HISTORIC AND DESIGN REVIEW COMMISSION

HDRC CASE NO: 2020-298
ADDRESS: 250 MARY LOUISE
LEGAL DESCRIPTION: NCB 6699 BLK 8 LOT 14& 15
ZONING: R-6, H
CITY COUNCIL DIST.: 7
DISTRICT: Monticello Park Historic District
APPLICANT: Gary Hudman/HUDMAN GARY S
OWNER: Gary Hudman/HUDMAN GARY S
TYPE OF WORK: Retaining wall installation, fenestration modifications, gate replacement
APPLICATION RECEIVED: June 18, 2020
60-DAY REVIEW: Not applicable due to City Council Emergency Orders
CASE MANAGER: Rachel Rettaliata

REQUEST:

Retaining Wall to Prevent Foundation Damage

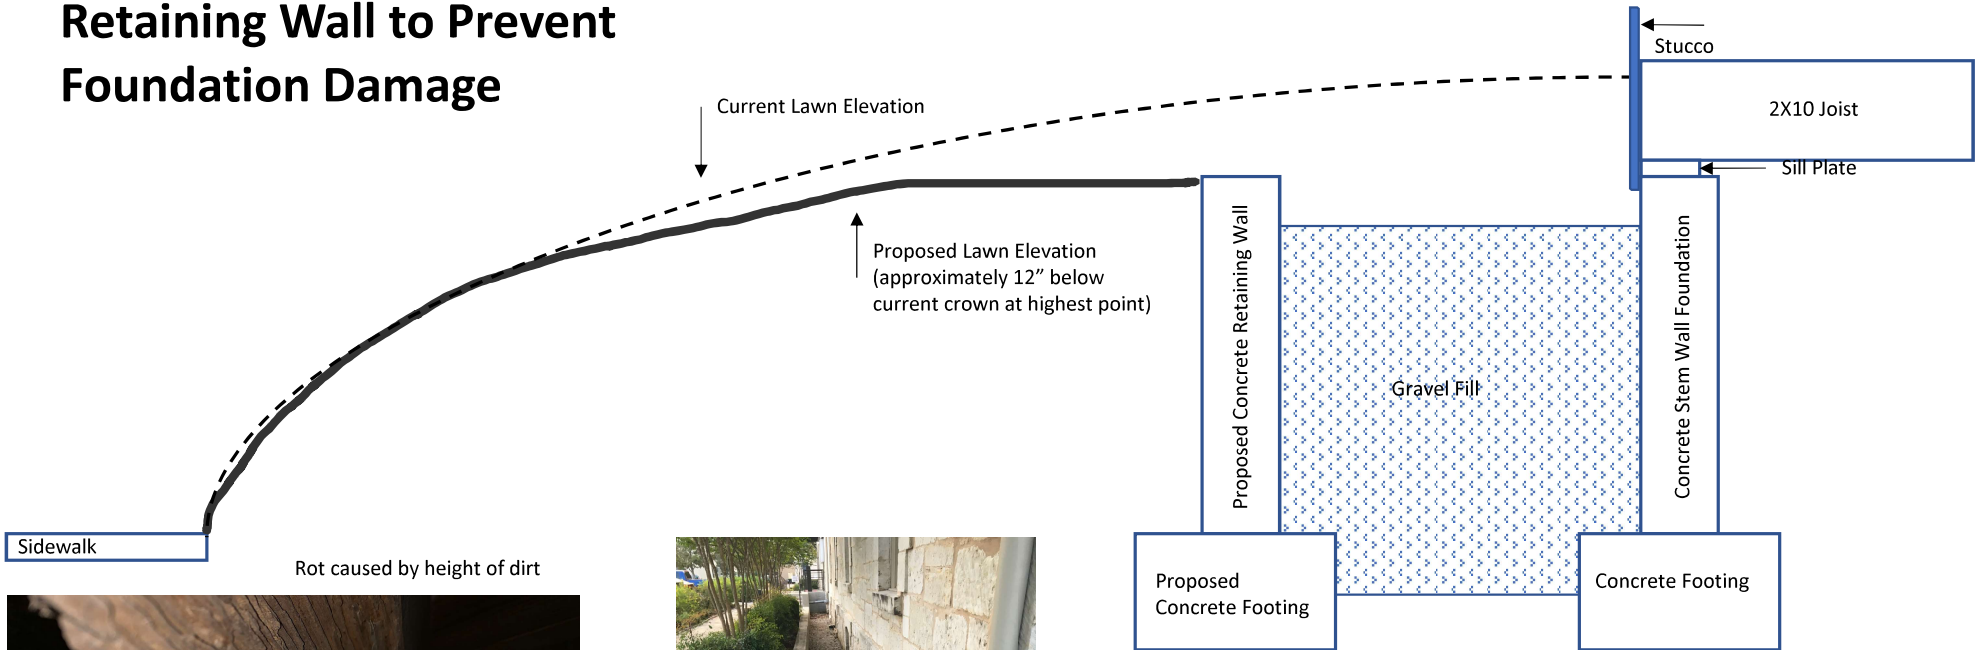
- d. RETAINING WALL INSTALLATION – The applicant has proposed to install a retaining wall along the front portion of the north elevation in order to mitigate foundation damage from water infiltration. The proposed retaining wall will be 30 inches from the façade and will be 12 inches below the current crown at its highest point. The proposed retaining wall will be constructed with a concrete footing, a concrete retaining wall and will be filled with gravel. The retaining wall will not alter the topography of the property and will not extend beyond the lawn elevation. Staff finds the proposal appropriate.

Staff recommends approval of items 1, 2, 3, and 4 based on findings a through g.

Proposed Steel Casement Window Additions

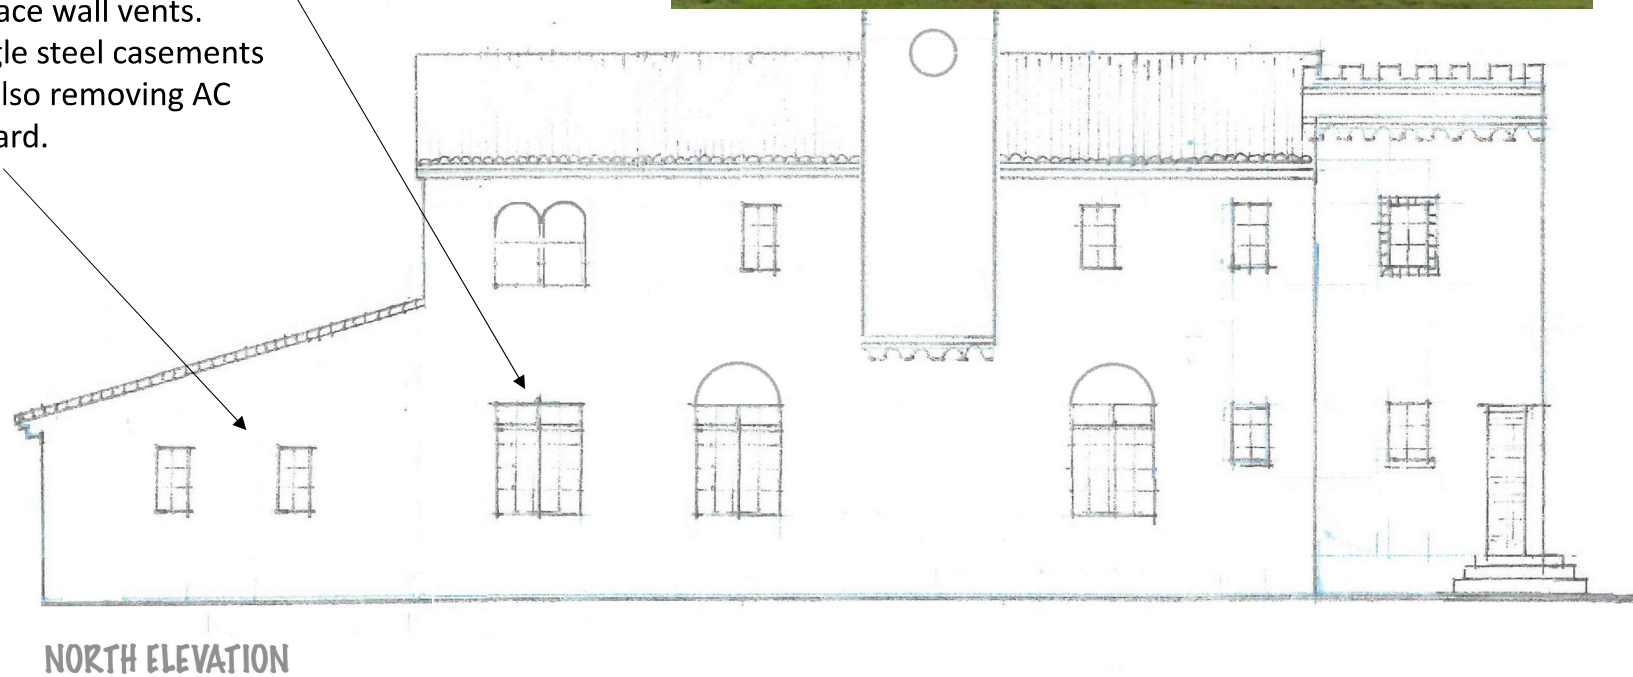
- e. FENESTRATION MODIFICATIONS: NORTH ELEVATION – The applicant has proposed to install 3 new steel casement windows at the rear of the north elevation. The applicant has proposed to install a double steel casement window to replace a window removed in 1953, this request was previously approved by the HDRC in 2012. Additionally, the applicant has proposed to install 2 single steel casement windows to replace existing wall vents. The proposed windows will match the existing steel casement windows on the north elevation. The applicant has additionally proposed to remove the existing A/C unit along this portion of the north elevation. Staff finds the proposal appropriate.

- 1) Double Steel Casement to replace the one removed in 1953 (already approved by HDRC on 11/7/12)
- 2) Single Steel Casements (2) proposed to replace wall vents. These match single steel casements on this façade. Also removing AC unit from front yard.

West Façade Proposal

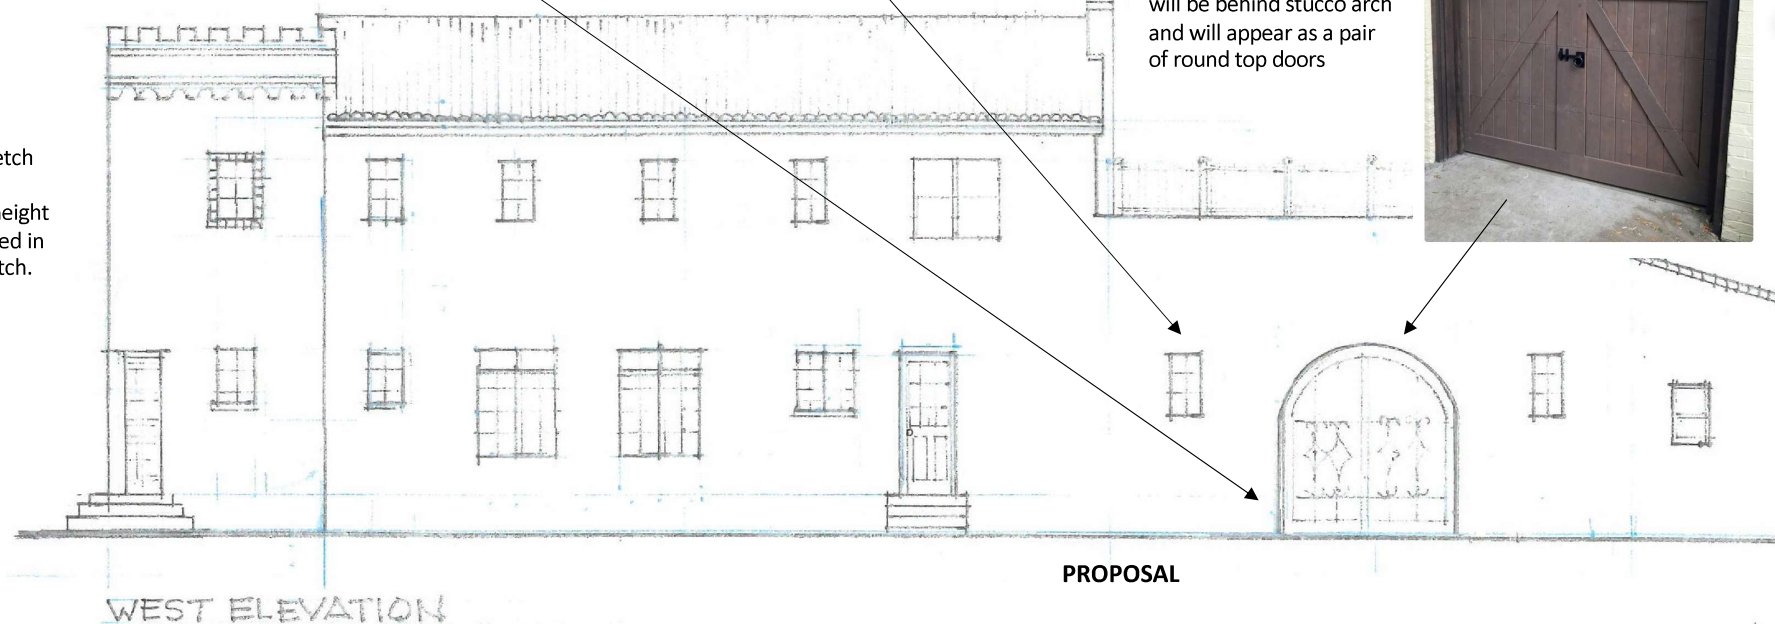
- f. FENESTRATION MODIFICATIONS: WEST ELEVATION – The applicant has proposed to amend the previous 2012 HDRC approval for small sidelight windows to accommodate the request for 2 single steel casement windows to be installed on each side of the archway on the west elevation. The proposed steel casement windows will match the existing steel casement windows on the west elevation. Staff finds the proposal appropriate.

- 1) Small sidelight windows in original proposal to be replaced with Single Steel Casements (2). These match single steel casements on this façade.
- 2) Originally proposed steel gates to be replaced with custom wooden “carriage-style” doors.

Note: original façade sketch depicted some slight inaccuracies in window height which have been corrected in the proposed façade sketch.

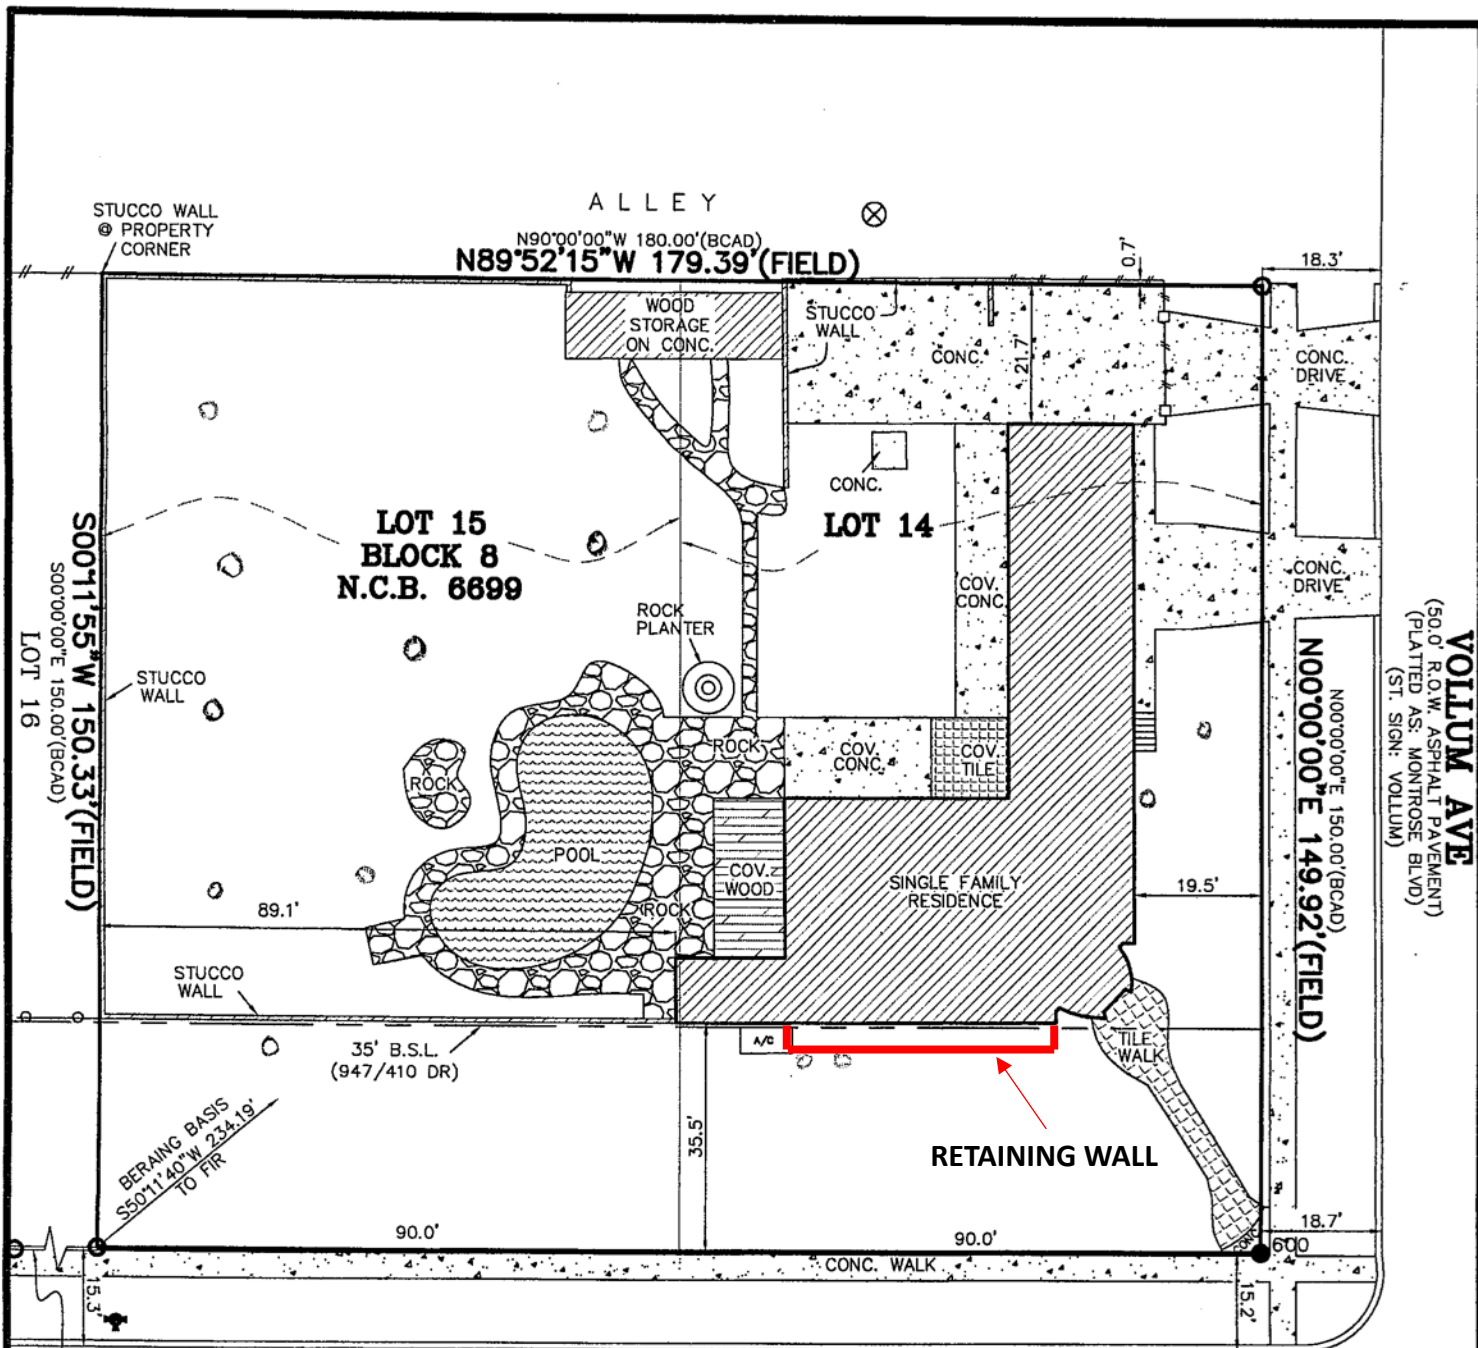
- g. DOOR AMENDMENT – The applicant has proposed to amend the previous 2012 HDRC approval for steel gates in the archway on the west elevation to accommodate the request for wooden carriage-style doors. The applicant has proposed to install a custom door that will be installed behind the stucco arch and will appear as a pair of rounded doors. Staff finds the proposal appropriate.

Note: Proposed door style. Actual custom door will be behind stucco arch and will appear as a pair of round top doors
